PROJECT **Revington-B**

TITLE **Revington-B**

SCALE 1:35 DRG. No. 002

DATE 01.05.2019 PLOT FILE 1st Floor Plan  
DRAWN BY C.C. A1-L

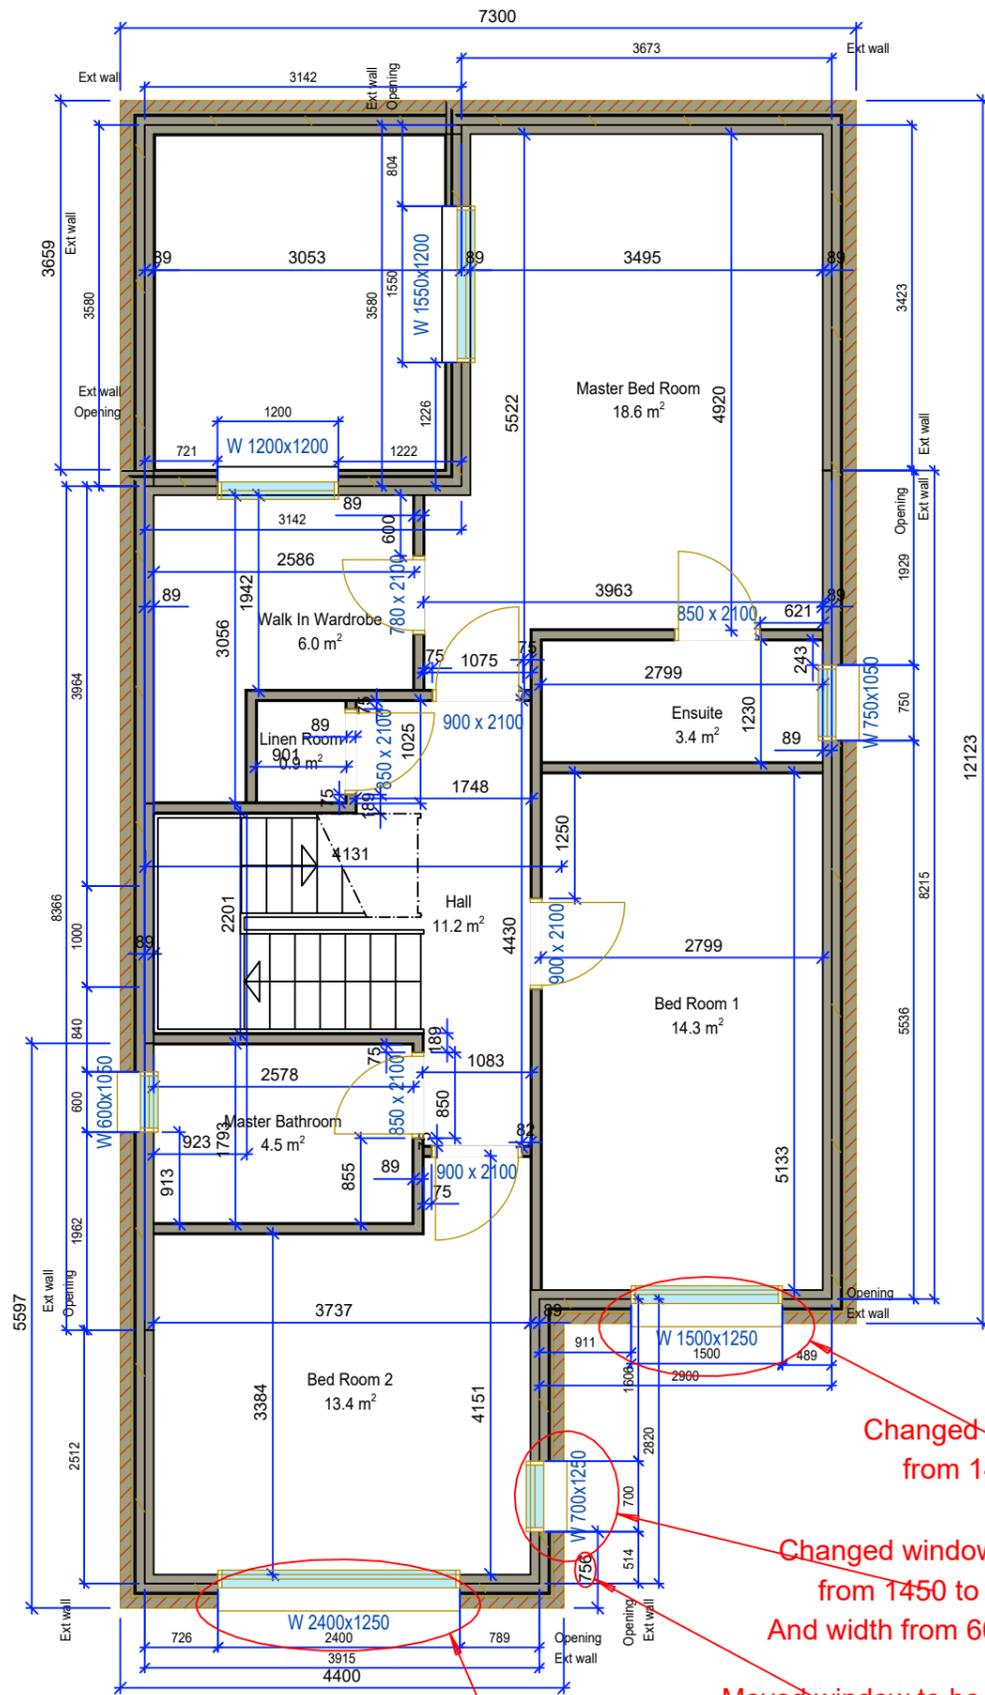
Changed window height  
from 1450 to 1250

Changed window height  
from 1450 to 1250  
And width from 600 to 700

Moved window to be in line  
with ground floor window and  
farther away from external corner  
Changed window height  
from 1450 to 1250

REV	DESCRIPTION	DATE
10	Fixed Bedroom 1 + 2 sill heights Moved Bedroom 2 side window to be more than 675mm from brick corner Changed width of bedroom 2 window to match ground floor window below	01/05/2019
9	D	25/04/2019
